D.H.O. FOUNDATION REPORT --
W.J. 60-F-49 -- W.P. 202-58.

Re: Fiddlers Green Road and Highway No. 403,
(Approx. 3 Miles North of Ancaster)
Twp. of Ancaster, County of Wentworth,
District no. 4.

Fiddlers Green Road Bridge,
W.P. 202-58 -- W.J. 60-F-49,
Hwy. #403, District #4.

We have reviewed the Preliminary Drawing No. D-5520-P1 for the above-mentioned structure, and submit our comments for your consideration:

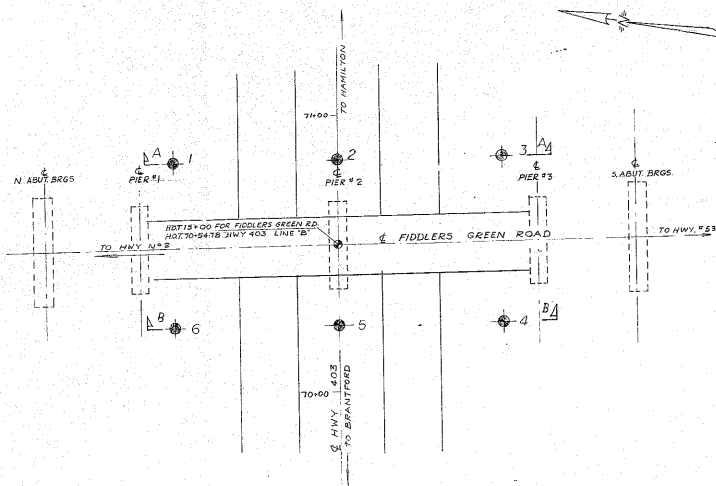
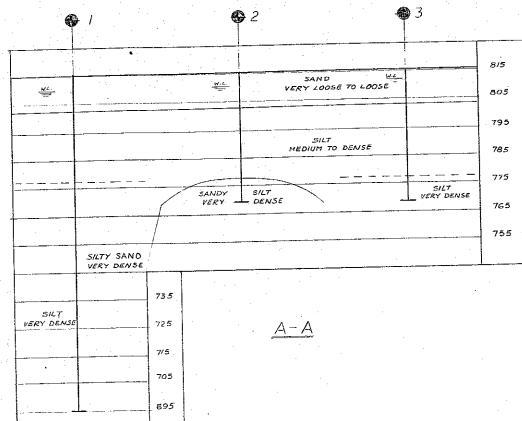
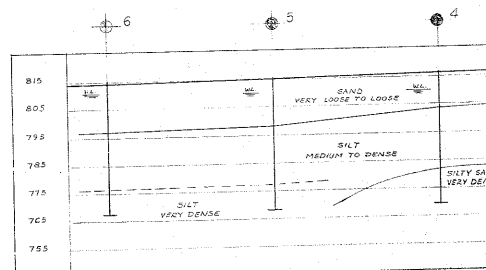
The subsoil conditions at this site were again reviewed in the light of the proposed footing design. Due to the considerable difference in density as established with dynamic cone and Standard penetration tests between the east (B.H.'s #1, 2, & 3) and the west side (B.H.'s #4, 5, & 6), piles may reach refusal at different elevations.

The following tip elevations may be used for estimating purposes of pile lengths:

East Side: (B.H. 1, 2, & 3) -- Elev. 795 - 785

West Side: (B.H. 4, 5, & 6) -- Elev. 775 - 765

During construction, the pile driving should be controlled by the Hiley Formula as per current D.H.G. Standards DD 1217 and DD 1218.

We would suggest that the possibility of having to drive piles of different lengths should be mentioned in the contract documents.
